# Appendix AA

## Public Comment Letters and Responses

### RE: Kern County Subbasin May 2024 Draft Groundwater Sustainability Plan - Subsidence

**RE: Response to Western State Petroleum Association (WSPA) Comments Dated August 29, 2024, on the May 2024 Draft Groundwater Sustainability Plan (GSP), Kern County Subbasin, Related to Land Subsidence.**

Figure 10: Conceptual strike cross section; Lost Hills Oil Field

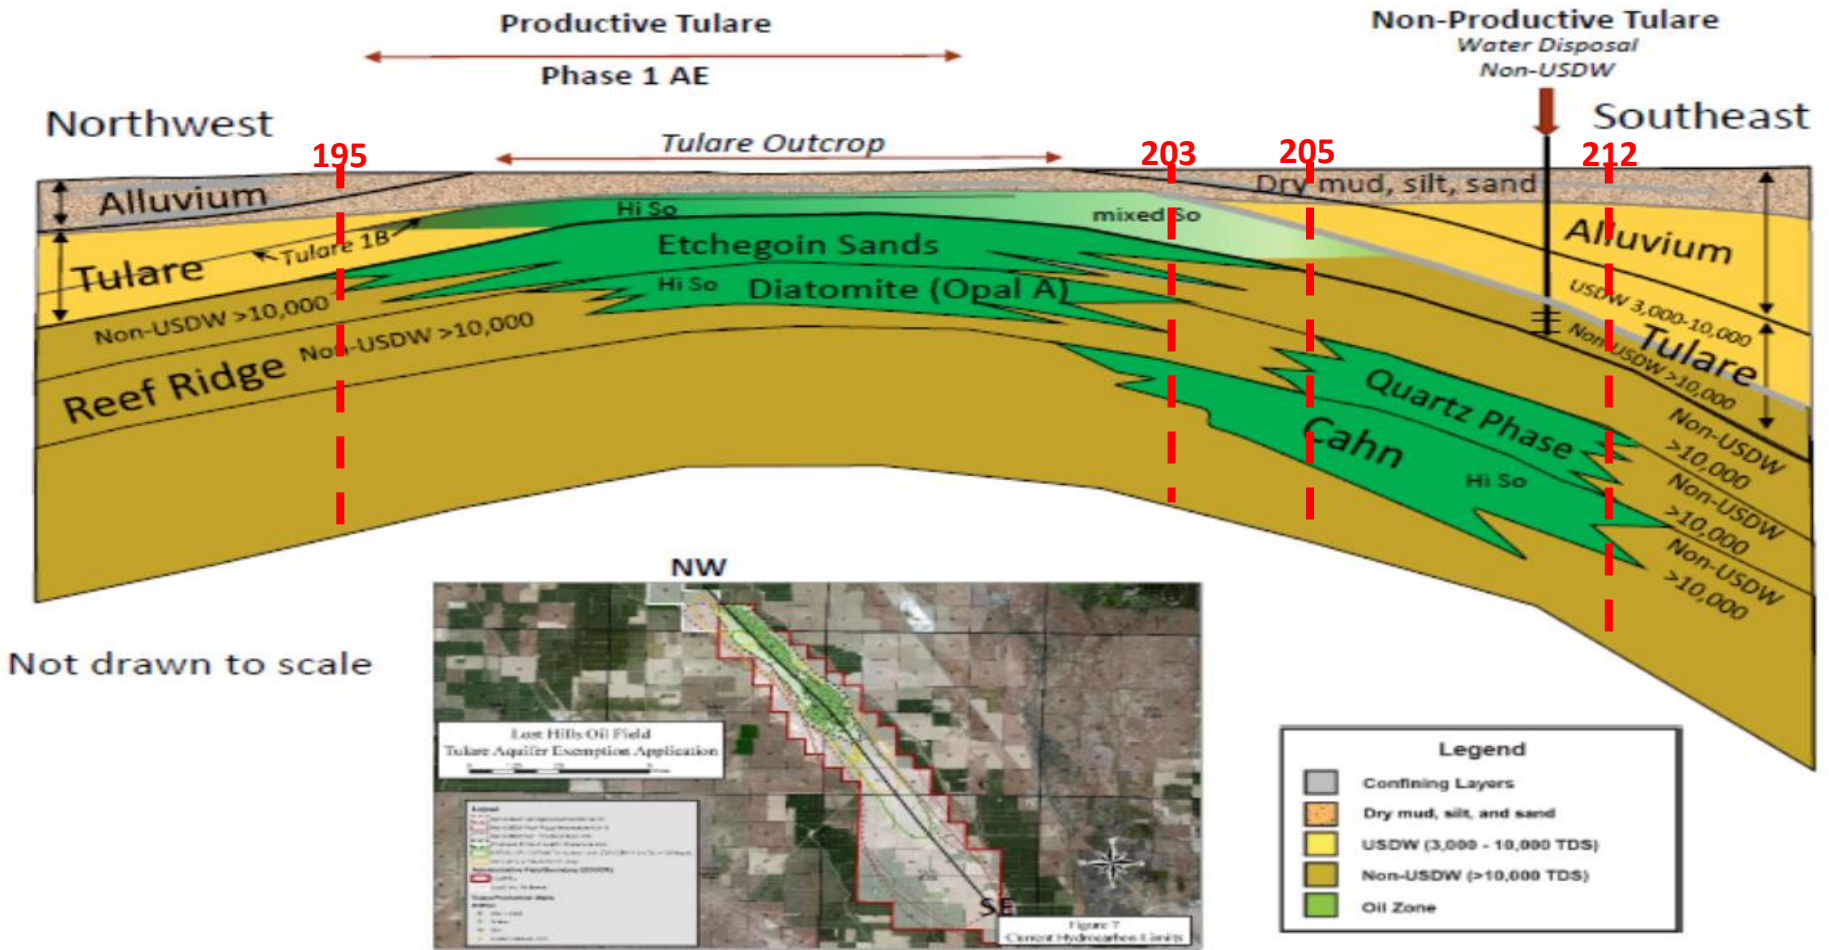
**WSPA Comment #3 – Summary:** Neither the ECI 2021 Report nor the LBNL 2022 Study consider reinjection of produced water, which is done specifically to address the localized subsidence within Lost Hills Oilfield.

**Response to Comment #3:** After the CASP’s September 2022 comment letter, the Subbasin provided subsequent data pertaining to CalGEM oil field production data and Underground Injection Control (UIC) information to the CASP regarding oil field fluids and dynamics. According to State Water Project (SWP) correspondence dated October 1, 2024, there are over 3,600 oil and gas wells in the Lost Hills Oil Field, many of these in the vicinity of MP 195-215. As WSPA is aware, reinjection of oil field produced water does not eliminate subsidence caused by oil extraction, at best it can only ameliorate it to a small extent, particularly when a significant volume of produced water is reinjected into deeper zones below oil production zones and the limits of the designated underground source of drinking water (USD) like at Lost Hills. The Lost Hills anticline reservoir is not a closed system, and according to a 1993 Chevron report, “*Massive hydraulic fracturing... has been employed since the 1980s*”. In other words, the produced water is not simply contained within the anticline structure itself, multiple pathways for fluid migration likely exist. As documented in UIC materials produced water is being drawn from areas adjacent to the crest of the oil field (i.e., up the limbs of the oil field anticline), likely including from beneath the Aqueduct by the subsurface pressure differential propagated by oil extraction at the crest of the reservoir structure. A

conceptual cross section from the Lost Hills UIC that illustrates this concept found in **Appendix B** of this response letter.

## Lost Hills UIC Oil Field Administrative Boundary Figure

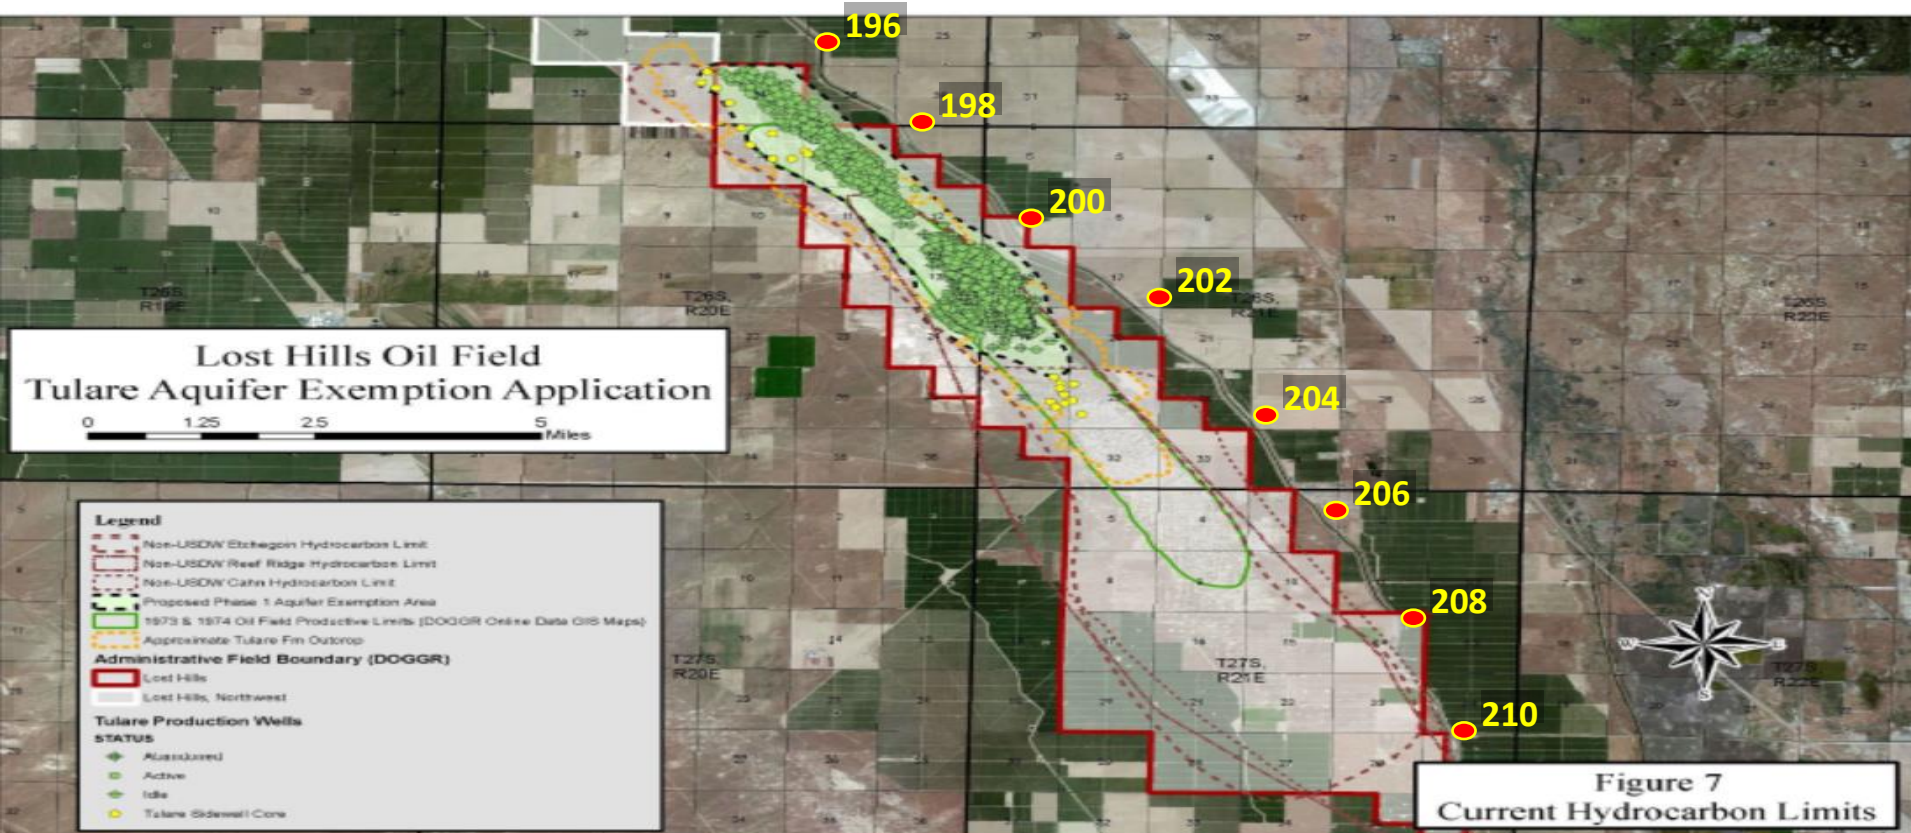
**WSPA Comment #7 – Summary:** 2023 LBL draft study did not establish that localized subsidence associated with Lost Hills Oilfield operations extended to the Aqueduct. The study failed to consider the fluid re-injection that occurs in Lost Hills Oilfield.

It is important to recall that the Lost Hills Oil Field is directly adjacent to the Aqueduct and in fact the administrative boundary of the field extends across the Aqueduct in places. A UIC figure illustrating this close relationship is provided in **Appendix B** of this response letter. In a June 1992 report by Chevron (**Appendix A**) presented the results of a finite element model that compared subsidence model results to field measurements of subsidence collected between 1989 and 1991. This data indicated that around 0.2 ft (2.4 inches) of subsidence could be expected approximately 3,000 ft (0.6 mile) from the center of the field. Since that time, the field has matured further, and enhanced oil recovery (EOR) activities have expanded. All of the contributing factors described herein, and others, were shared in meetings with CASP and at least once jointly with CASP and CalGEM in September 2023. Lastly, the aforementioned number and density of oil field-related wells (over 3,600) in comparison to GSA-related wells adjacent to the Aqueduct between MP 195 and 215 in the five mile-wide CASP monitoring corridor are orders of magnitude apart. Two figures based on CalGEM information illustrating this fact are found in **Appendix B** of this response letter. This disparity in the number of wells is relevant when it is understood that, because of naturally degraded groundwater quality the WDWA GSA relies almost exclusively on surface water deliveries from the Aqueduct and other sources for its supply needs (i.e., over 98 percent surface water). Recently, WDWA GSA received a CEQA project description from CalGEM pertaining to a proposed Chevron project to drill an additional 75 wells in the Lost Hills Field, further demonstrating extraction plans for the Lost Hills Field are ongoing and expanding.

**Response to Comment #7:** Please the response to **Comment #3**. The administrative boundaries of the Lost Hills Oil Field abut and extend over the Aqueduct in places. With regards to WSPA implying that reinjection of produced water is a means of eliminating subsidence or otherwise abrogating oil activities from subsidence impacts on the Aqueduct, the data shows such a claim to be misleading at best. In addition to the oil company publications cited in Response to **Comment #3**, a 1993 Mobil Oil publication titled *Lost Hills Dolomite Simulation Study: Predicting Waterflood Performance in a Low-Permeability, Compacting Reservoir*, stated, *“In the late 1980’s, it became evident that production from the tightly spaced (as low as 0.42 acre) development of these highly compressible permeability reservoir was resulting in reservoir compaction and surface subsidence”*. The Lost Hills Oil field diatomite reservoir is adjacent to the Aqueduct where an embankment failure occurred at MP 208. On September 17, 2024, CalGEM circulated a California Environmental Quality Act (CEQA) Project Description seeking comment on a Chevron project to, among other things, drill another 75 wells in the Lost Hills Oil Field. The focus of this project is the same collapse prone diatomite reservoir adjacent to the Aqueduct. In a response to CalGEM, the SWP in a correspondence dated October 1, 2024, stated that currently there are well over 3,600 oil and gas wells in the vicinity of the Lost Hills Field and MP 195-215 and that “because significant and unavoidable geologic and soil (subsidence) and water facility (the Aqueduct) impacts

**2019 California Aqueduct Plates MP 195-215**

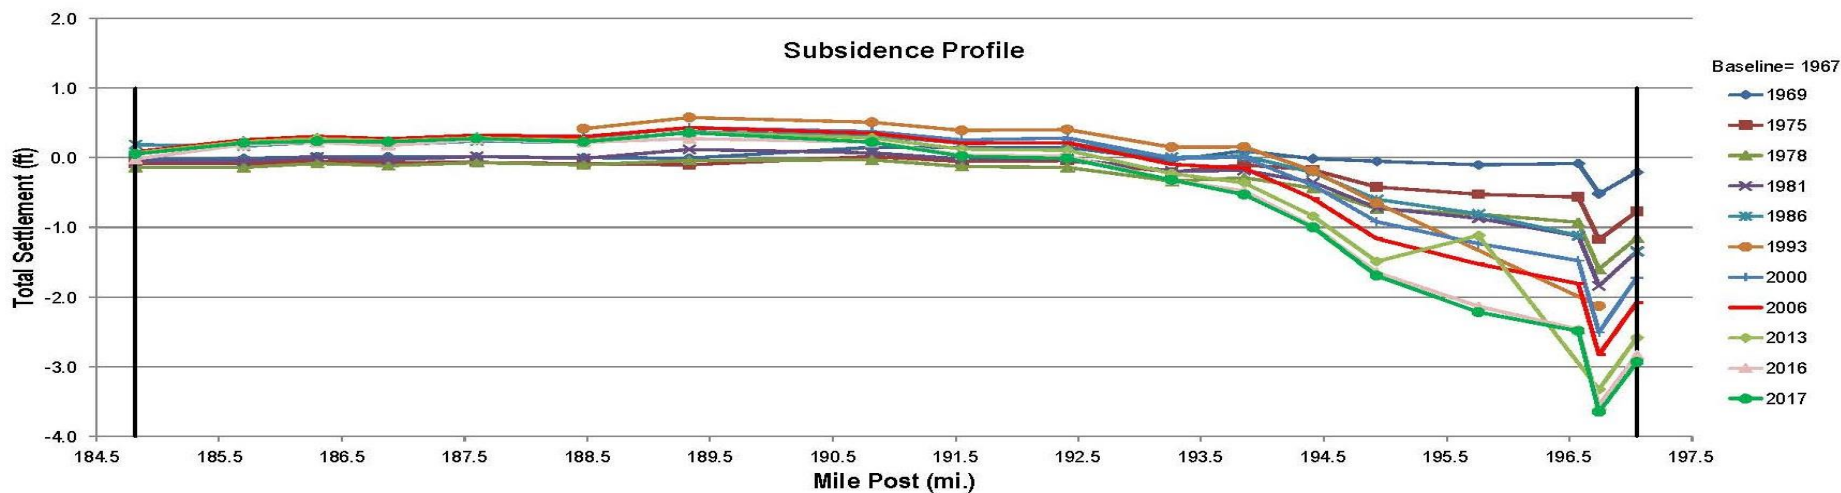
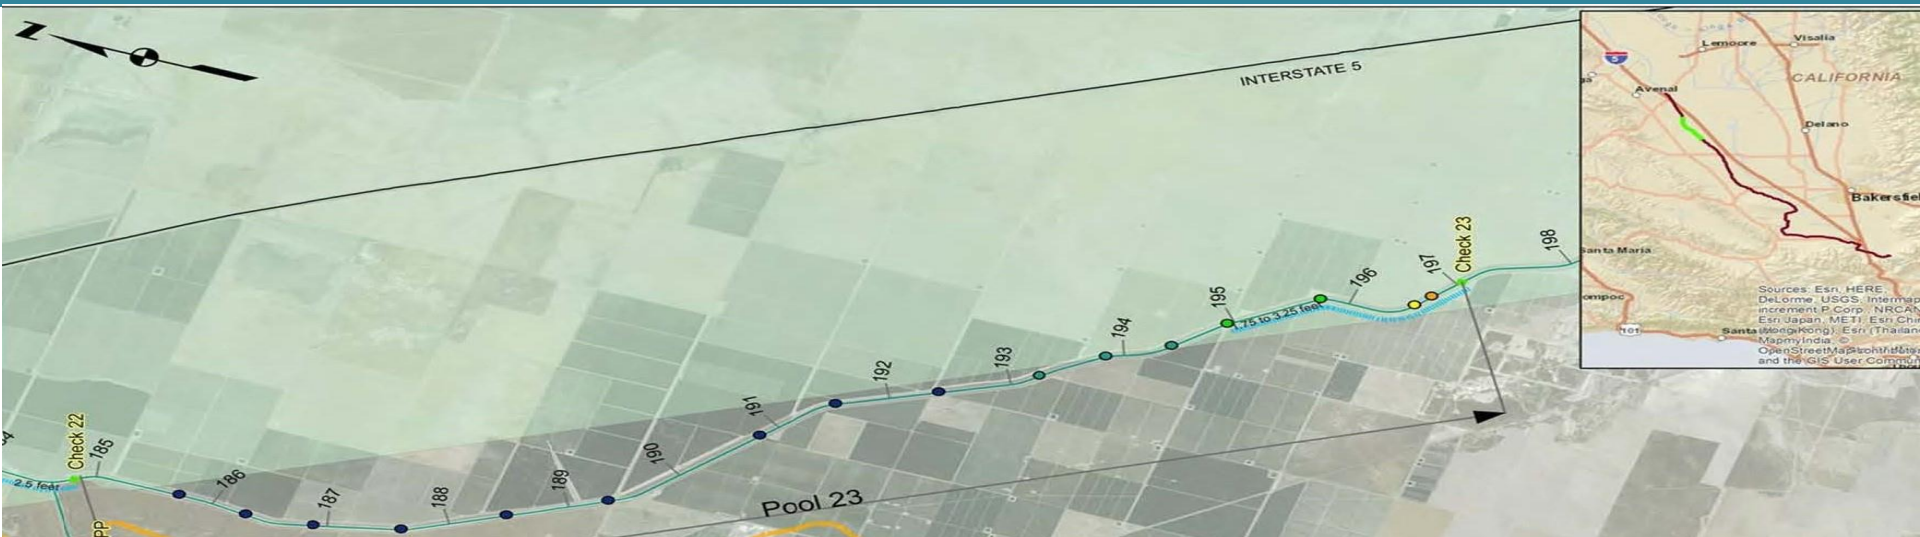
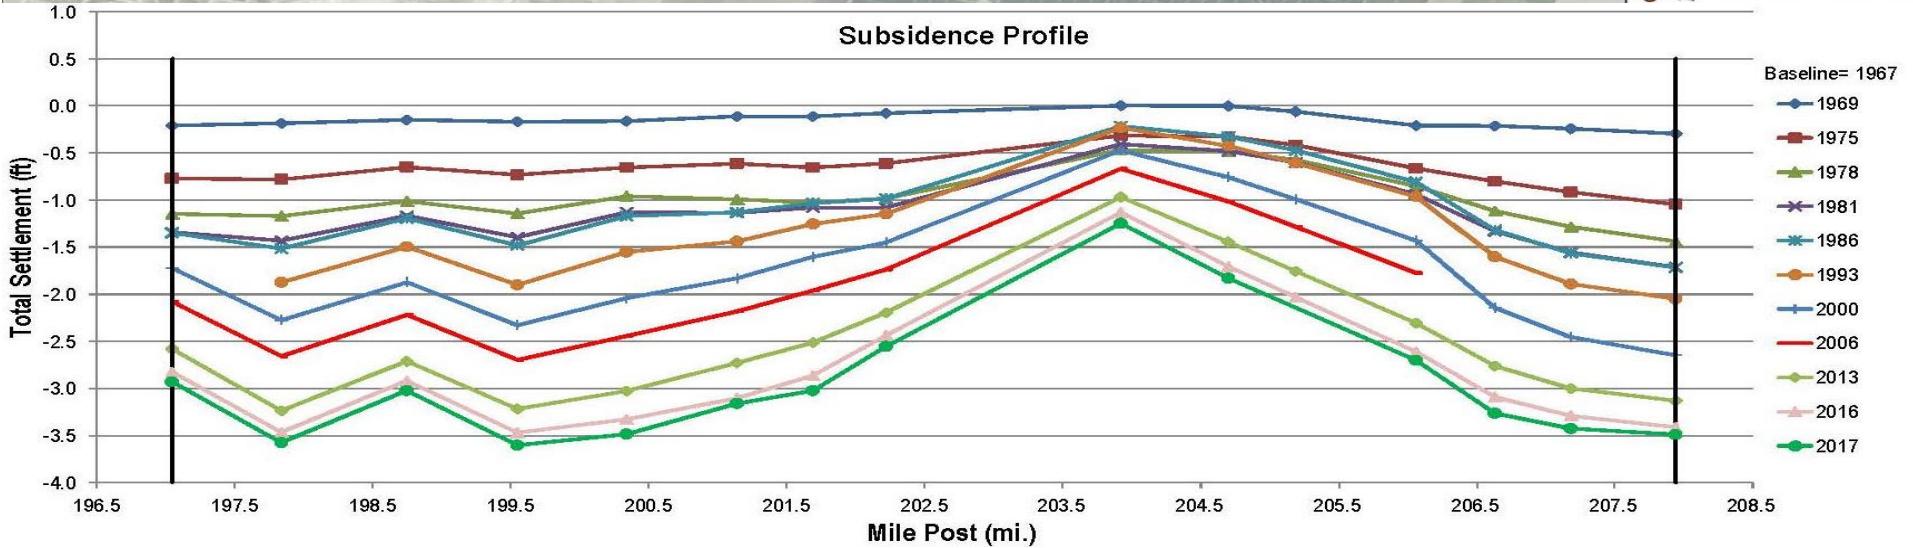
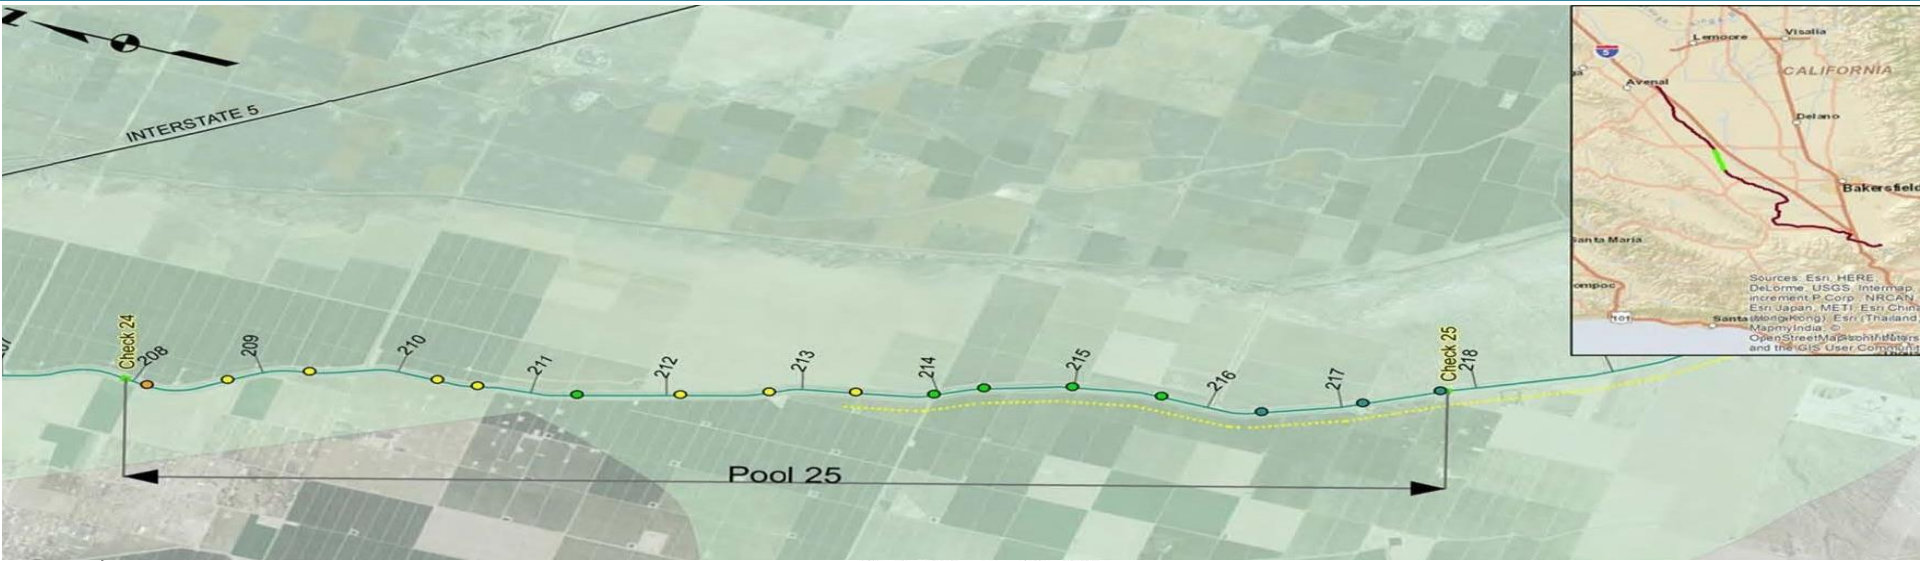
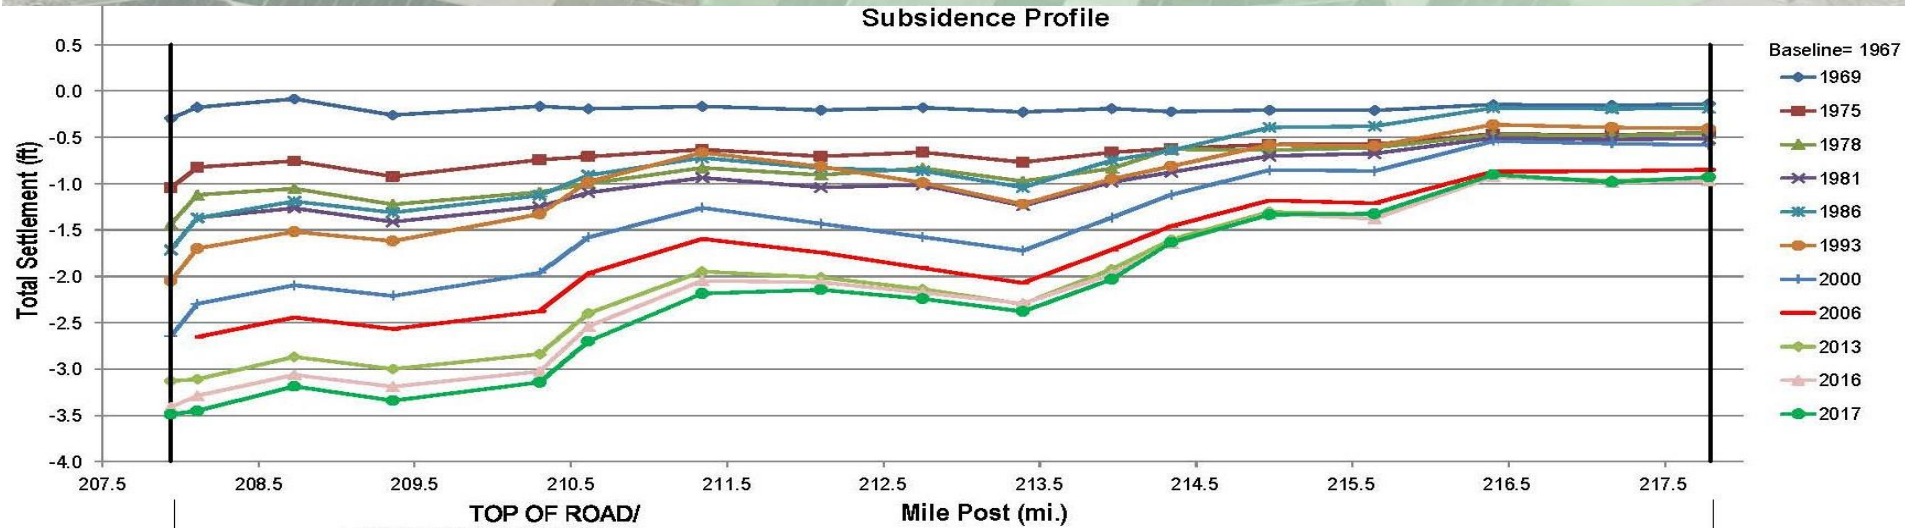
**WSPA Comment #8 – Summary:** The May 2024 Draft GSP fails to reference or evaluate earlier regulatory agency studies spanning several decades that reached different conclusions with respect to the causes of subsidence associated with the Aqueduct in the vicinity to Lost Hills.

As noted in Response to **Comment # 5**, the DWR *2019 California Aqueduct Subsidence Study: Supplemental Report*, land subsidence survey profiles provided on Plates 12 through 14 (**Appendix D**) of this response letter) show that significantly increased rates of subsidence correlate to the beginning of Lost Hills Oil Field activities at approximately MP 195 and extend along the Lost Hill Oil Field to approximately MP 215 where oil activities currently end or are reduced. In regard to WSPA’s comment that, “*the California Aqueduct Subsidence Study: Supplemental Report, relying on several lines of evidence (including an expanded 5 mile buffer zone on either side of the Aqueduct), concluded that, “subsidence associated with oilfield operations in the Lost Hills area is localized to the Lost Hills Oilfield and does not extend to the Aqueduct with subsidence background rates west of the Aqueduct”*”, new data show otherwise. In fact, CASP, in their December 21, 2023, response letter to WSPA state, “*These studies [the 2017 California Aqueduct Subsidence Study and the subsequent 2019 supplemental California Aqueduct Subsidence Study] contributed to the body of knowledge of subsidence along the Aqueduct. However, given the limited data and information on which these studies were based, it is important that the interpretations they contain not be viewed as the definitive 'end of the story,' but rather an important step towards a collective understanding of the causes of subsidence affecting the California Aqueduct.*” (emphasis added)

While the aforementioned 2019 DWR figures are but one source of data, when viewed with other disparate sources of data, many of which were prepared by WSPA member companies, a reasonable conclusion is that a nexus exists between oil extraction and subsidence impacts to the Aqueduct. Examples of the other data reviewed by the Subbasin are presented in Appendix A and summarized above in Response to WSPA **Comment #1**. As stated elsewhere in this response letter, the Subbasin plans to work cooperatively with CASP and DWR to monitor and further study this phenomenon as those agencies work to apportion responsibility among the various stakeholders for the undesirable results identified between MP 195 and 215.
